PRODUCT CHANGE NOTIFICATION (PCN)

A-MCSP60010/B MODULAR CABLE

CHANGE NOTIFICATION: PCN 20220425_A-MCSP60010/B

DESCRIPTION OF CHANGES: CHANGE OF DATA SHEET
CHANGE OF DATA SHEET
New Draw.-No. ASS_7542_CArev04

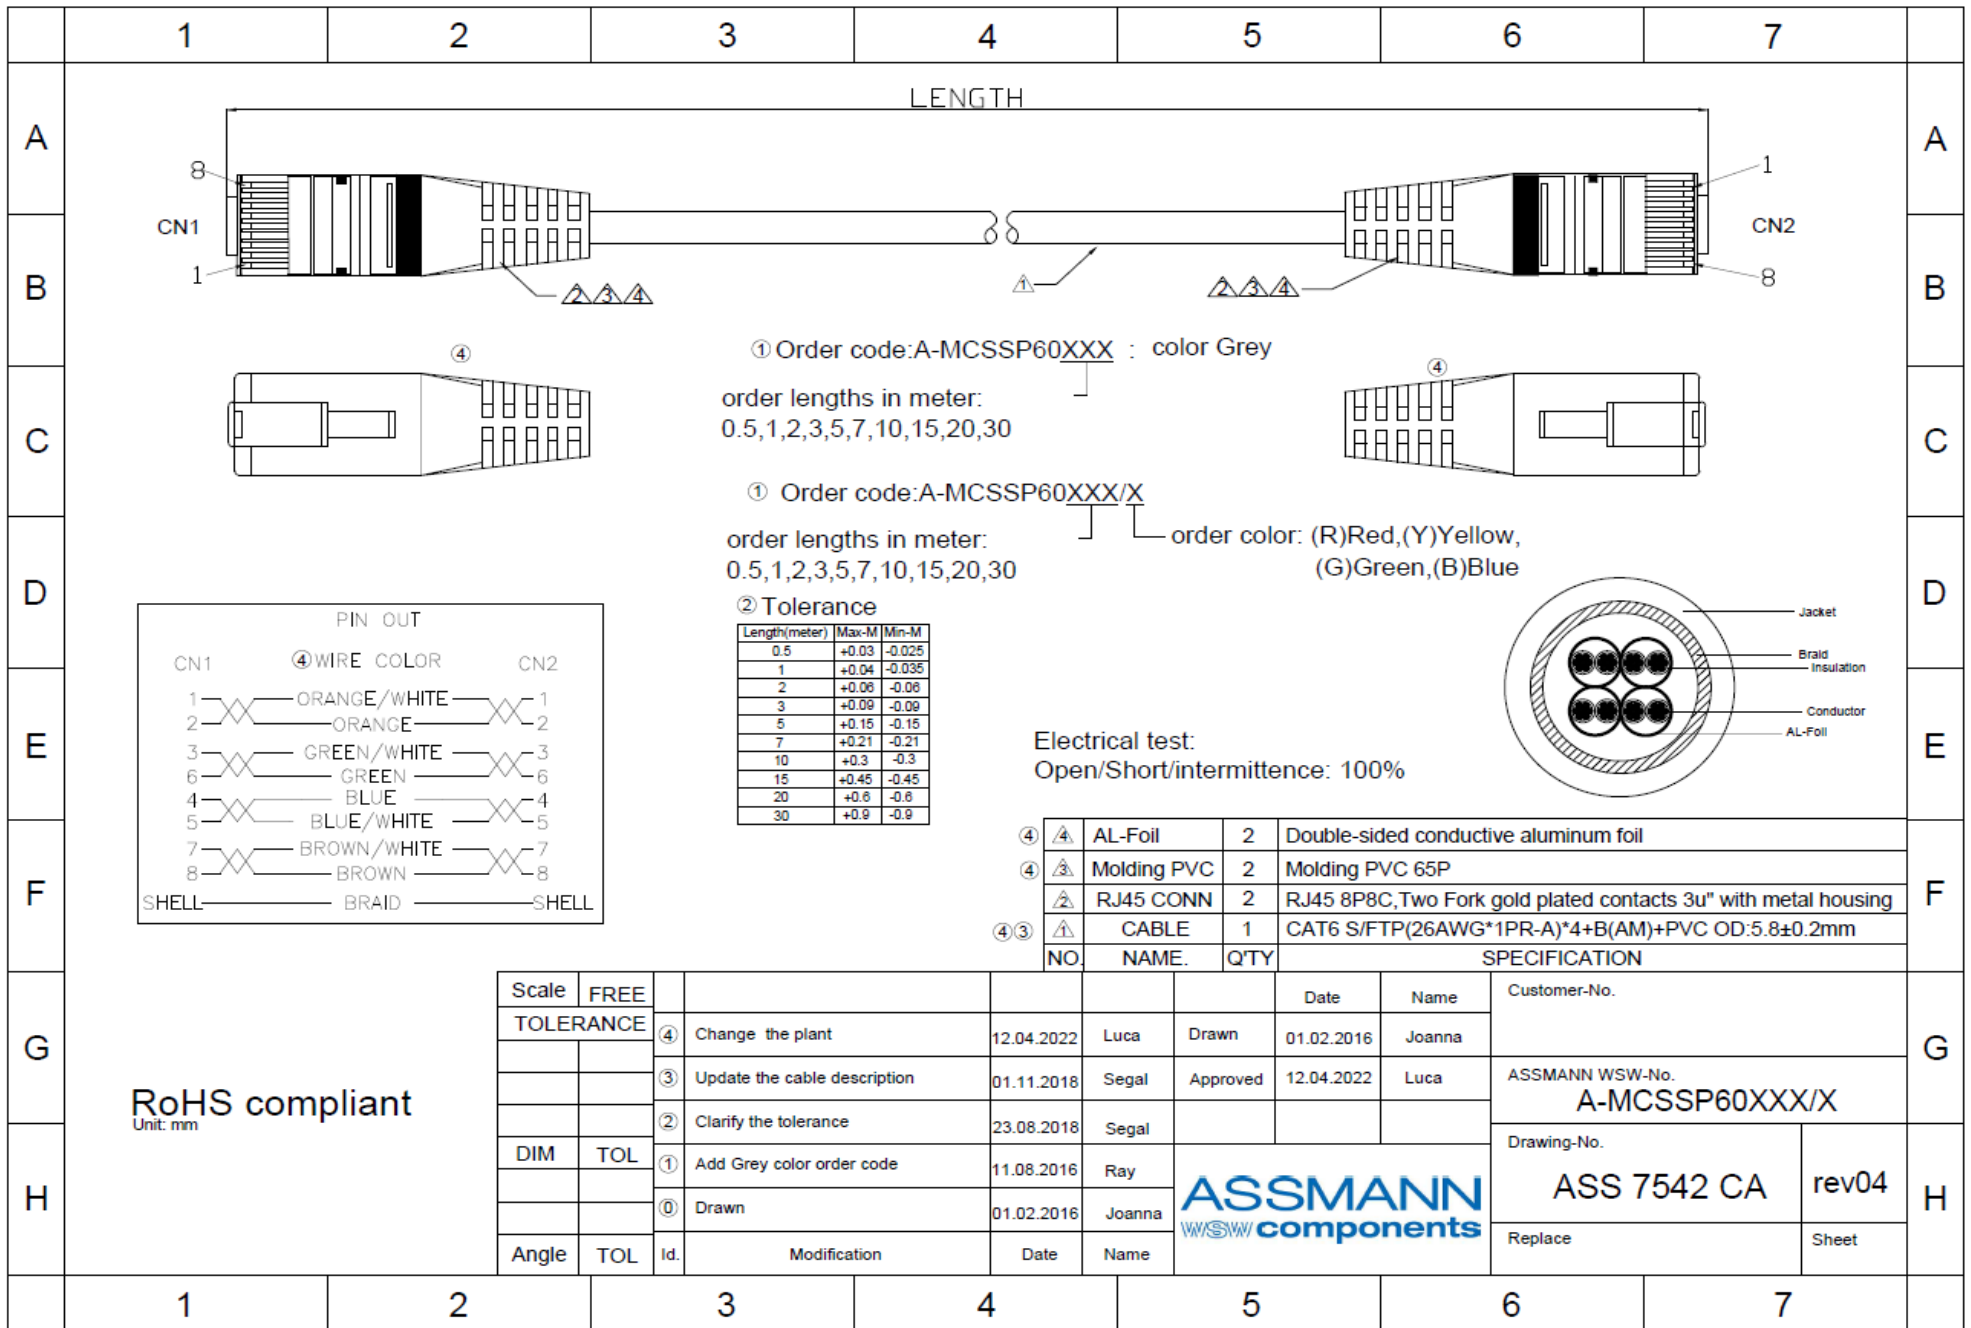
A-MCSP60010/B	OLD VERSION	A-MCSP60010/B	NEW VERSION																																				
<p>Appearance</p>		<p>Appearance</p>																																					
<p>BOM</p> <table border="1"> <thead> <tr> <th>NO.</th> <th>NAME.</th> <th>QTY</th> <th>SPECIFICATION</th> </tr> </thead> <tbody> <tr> <td>③</td> <td>△ Molding PVC</td> <td>2</td> <td>Molding PVC 45P</td> </tr> <tr> <td></td> <td>△ RJ45 CONN</td> <td>2</td> <td>RJ45 8P8C, Two Fork gold plated contacts 3u" with metal housing</td> </tr> <tr> <td></td> <td>△ CABLE</td> <td>1</td> <td>CAT6 S/FTP(26AWG*1PR-A)*4+B+PVC OD:5.8±0.2mm</td> </tr> </tbody> </table>		NO.	NAME.	QTY	SPECIFICATION	③	△ Molding PVC	2	Molding PVC 45P		△ RJ45 CONN	2	RJ45 8P8C, Two Fork gold plated contacts 3u" with metal housing		△ CABLE	1	CAT6 S/FTP(26AWG*1PR-A)*4+B+PVC OD:5.8±0.2mm	<p>BOM</p> <table border="1"> <thead> <tr> <th>NO.</th> <th>NAME.</th> <th>QTY</th> <th>SPECIFICATION</th> </tr> </thead> <tbody> <tr> <td>④</td> <td>△ AL-Foil</td> <td>2</td> <td>Double-sided conductive aluminum foil</td> </tr> <tr> <td>④</td> <td>△ Molding PVC</td> <td>2</td> <td>Molding PVC 65P</td> </tr> <tr> <td></td> <td>△ RJ45 CONN</td> <td>2</td> <td>RJ45 8P8C, Two Fork gold plated contacts 3u" with metal housing</td> </tr> <tr> <td>④③</td> <td>△ CABLE</td> <td>1</td> <td>CAT6 S/FTP(26AWG*1PR-A)*4+B(AM)+PVC OD:5.8±0.2mm</td> </tr> </tbody> </table>		NO.	NAME.	QTY	SPECIFICATION	④	△ AL-Foil	2	Double-sided conductive aluminum foil	④	△ Molding PVC	2	Molding PVC 65P		△ RJ45 CONN	2	RJ45 8P8C, Two Fork gold plated contacts 3u" with metal housing	④③	△ CABLE	1	CAT6 S/FTP(26AWG*1PR-A)*4+B(AM)+PVC OD:5.8±0.2mm

NO.	NAME.	QTY	SPECIFICATION																																				
③	△ Molding PVC	2	Molding PVC 45P																																				
	△ RJ45 CONN	2	RJ45 8P8C, Two Fork gold plated contacts 3u" with metal housing																																				
	△ CABLE	1	CAT6 S/FTP(26AWG*1PR-A)*4+B+PVC OD:5.8±0.2mm																																				
NO.	NAME.	QTY	SPECIFICATION																																				
④	△ AL-Foil	2	Double-sided conductive aluminum foil																																				
④	△ Molding PVC	2	Molding PVC 65P																																				
	△ RJ45 CONN	2	RJ45 8P8C, Two Fork gold plated contacts 3u" with metal housing																																				
④③	△ CABLE	1	CAT6 S/FTP(26AWG*1PR-A)*4+B(AM)+PVC OD:5.8±0.2mm																																				
<p>FOR DETAIL, PLEASE TAKE ATTACHED NEW DRAWING: FOR REFERENCE</p>

ASSMANN WSW-No. A-MCSP60XXX/X	
Drawing-No. ASS 7542 CA	rev04
Replace	Sheet

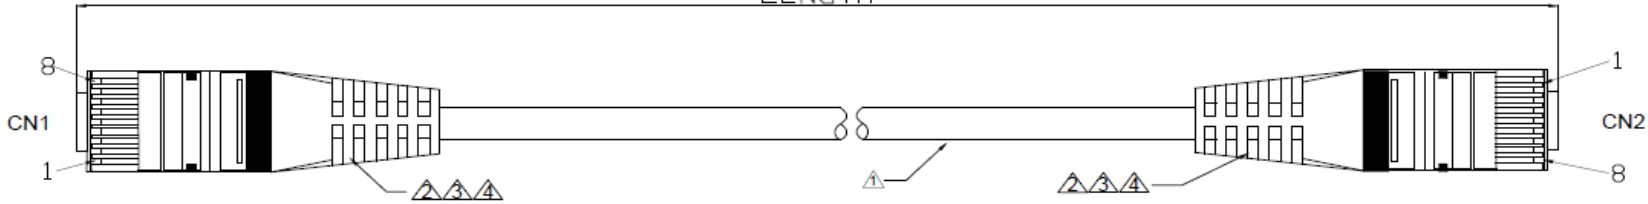
④	④	AL-Foil	2	Double-sided conductive aluminum foil
④	③	Molding PVC	2	Molding PVC 65P
	②	RJ45 CONN	2	RJ45 8P8C, Two Fork gold plated contacts 3u" with metal housing
④③	①	CABLE	1	CAT6 S/FTP(26AWG*1PR-A)*4+B(AM)+PVC OD:5.8±0.2mm
NO.	NAME.	Q'TY	SPECIFICATION

Scale	FREE					Date	Name	Customer-No.
TOLERANCE		④	Change the plant	12.04.2022	Luca	Drawn	01.02.2016	Joanna
		③	Update the cable description	01.11.2018	Segal	Approved	12.04.2022	Luca
		②	Clarify the tolerance	23.08.2018	Segal			
DIM	TOL	①	Add Grey color order code	11.08.2016	Ray			
		①	Drawn	01.02.2016	Joanna			
Angle	TOL	Id.	Modification	Date	Name
